INFRASTRUCTURE PROGRAMMES GROUP

Appendix A1 to

Statutory Consultation Response – March 2018

A303 Sparkford to Ilchester

Figure 1 (Westbound Podimore Slip)

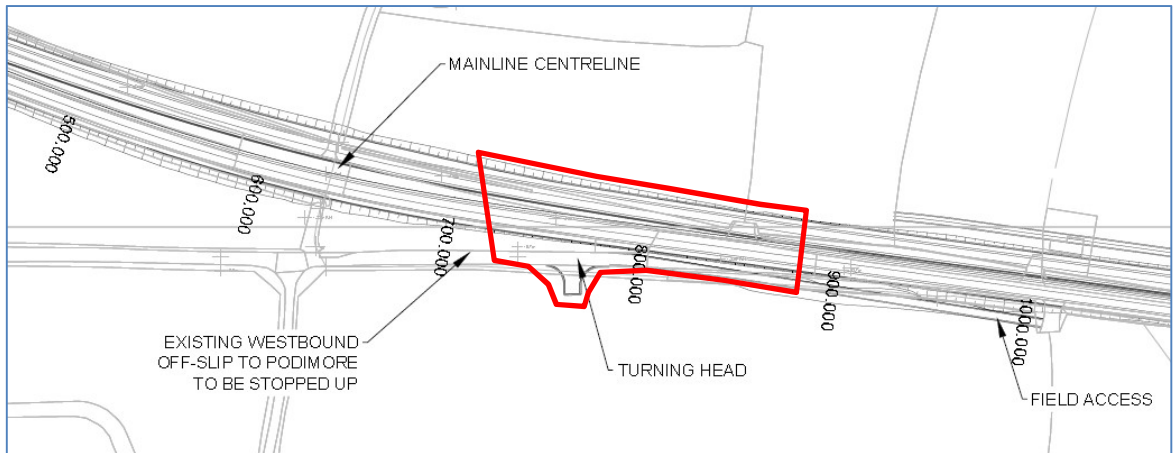
- 2.2.1 The Highway Authority supports the developer's proposal to close the exiting westbound off slip to Podimore.

Figure 2 (Camel Cross Cross Junction)

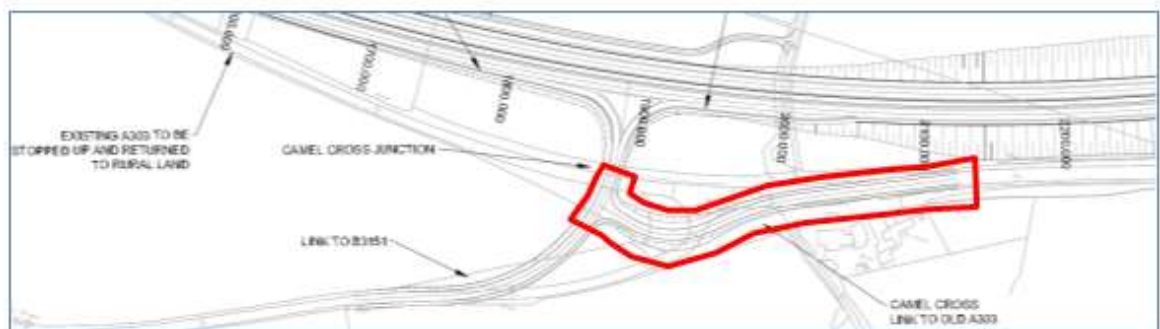
- 2.3.1 The Highway Authority has concerns that the junction of the Camel Cross Link with the old A303 (Fig.2) is too close to the new junction (Fig.1.0). The potential for conflict with turning vehicles is considered significant.
- 2.3.2 For the above reason, The Highway Authority do not support the developer's proposals for this junction.
- 2.3.3 The Highway Authority would be happy to work with the developer to review alternative alignment configurations that might assist in resolving the aforementioned concerns.

Figure 3 (Downhead Lane)

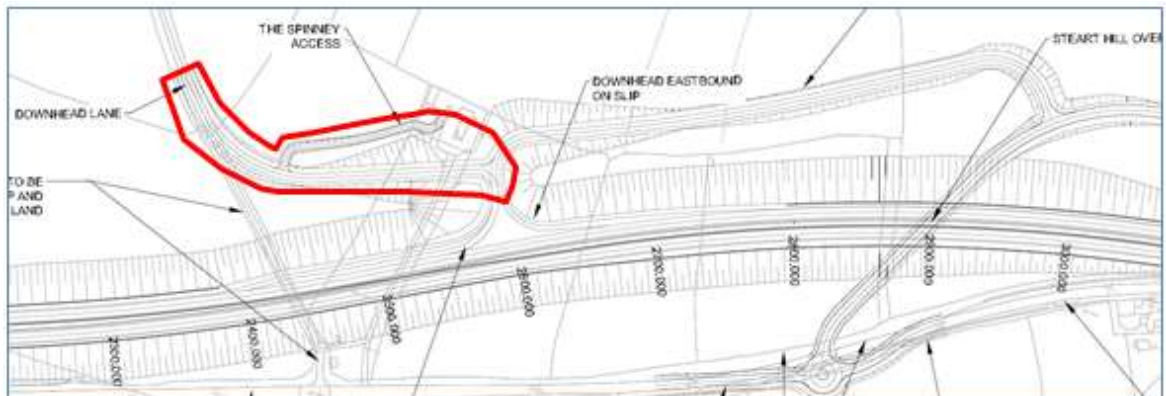
- 2.4.1 The Highway Authority has concerns regarding the proximity of the Downhead Lane junction (Figure 3) with the exit slip of the A303 and the potential for conflict with turning vehicles.

Figure 4 (Downhead junction link)

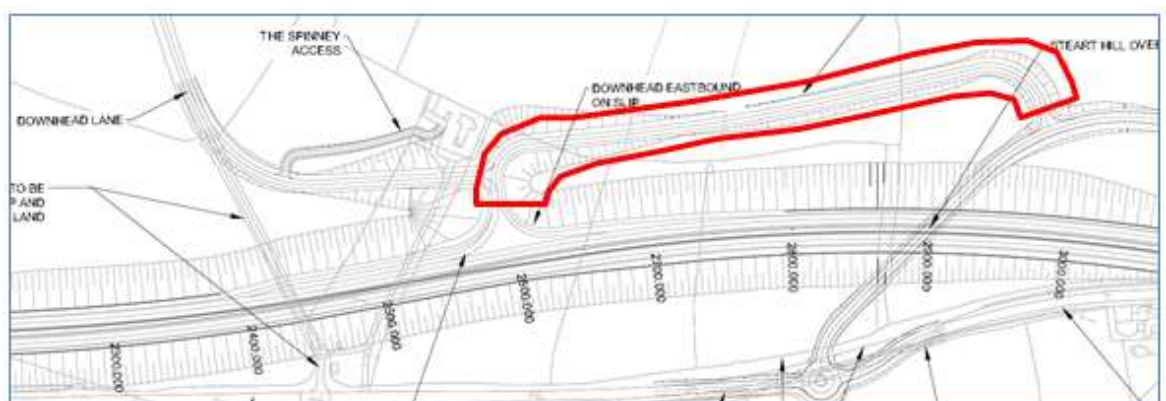
- 2.4.2 It is not clear from the information provided what standard the linking section (figure 4) has been designed in accordance with. It is suggested that the design standard for this section is TD40/94 Layout of Compact Grade Separated Junctions.
- 2.4.3 The Highway Authority has concerns regarding the long straight section of carriageway (figure 4) that might encourage higher vehicle speeds. Paragraph 6.4 of TD40/94 states that long straight sections within the compact connector should be avoided.

- 2.4.4 The Highway Authority also has concerns regarding the road hierarchy as the proposed trunk road terminates at a junction with a lesser category road (Stearth Hill overbridge).

2.4.5 For the above reasons, The Highway Authority does not support the developer's proposals for the Downhead Junction arrangement.

2.4.6 The Highway Authority would be happy to work with the developer to review alternative alignment configurations that might assist in resolving the aforementioned concerns.

Figure 5 (Vale Farm Link)

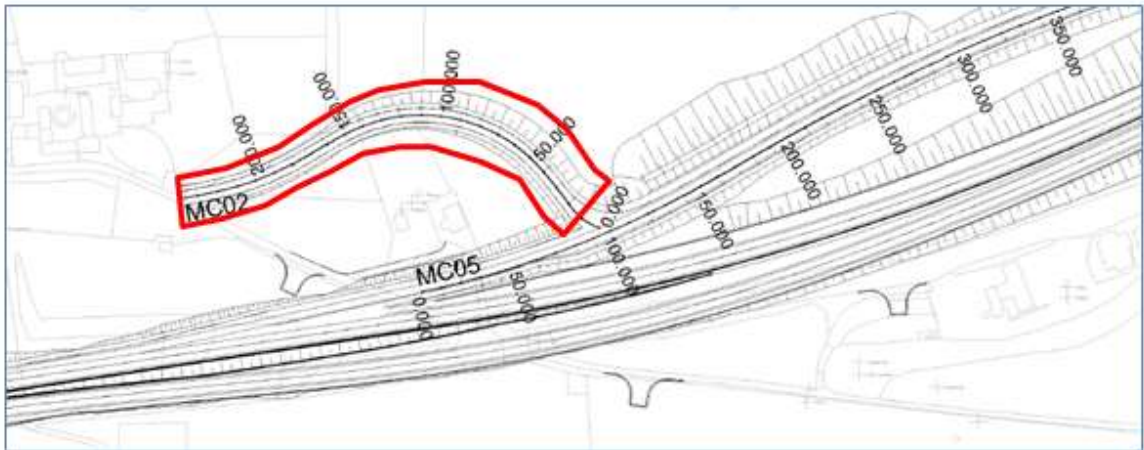
2.5.1 The Highway Authority considers that the close proximity of the Vale Farm junction (Fig.5) to the A303 eastbound off slip is unacceptable.

Figure 6 (Camel Hill Link)

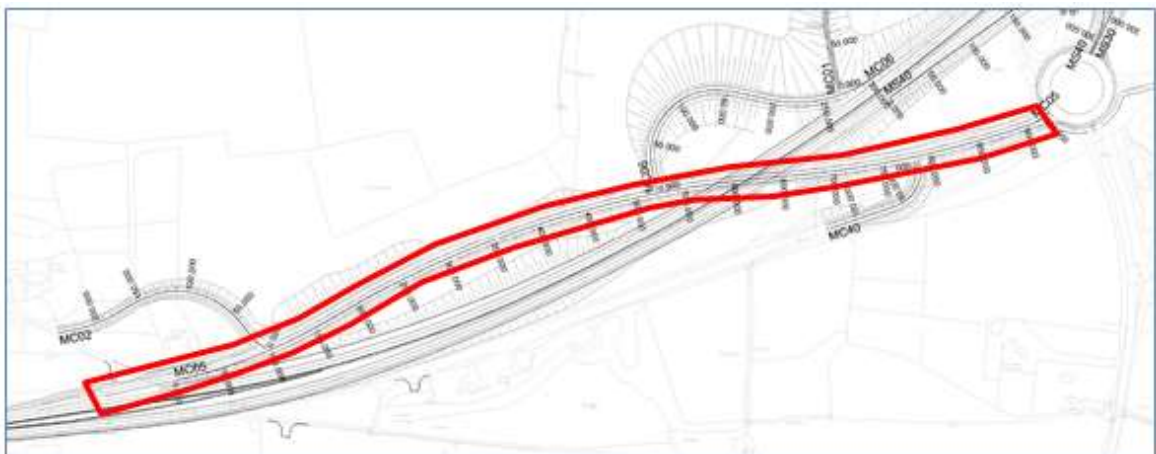
2.5.2 It is not clear from the information provided what standard this road is being designed to. It does not appear to be a slip road or an interchange link. It is too long for a slip road as it is in excess of 750m and west bound traffic cannot access the A303 once they have passed the Hazlegrove junction.

- 2.5.3** The Highway Authority has concerns that the link does not appear to be designed in accordance with the Design Manual for Roads and Bridges. There do not appear to be any existing examples of this type of layout on the Strategic Road Network. Local traffic and trunk road should be separated as much as possible.
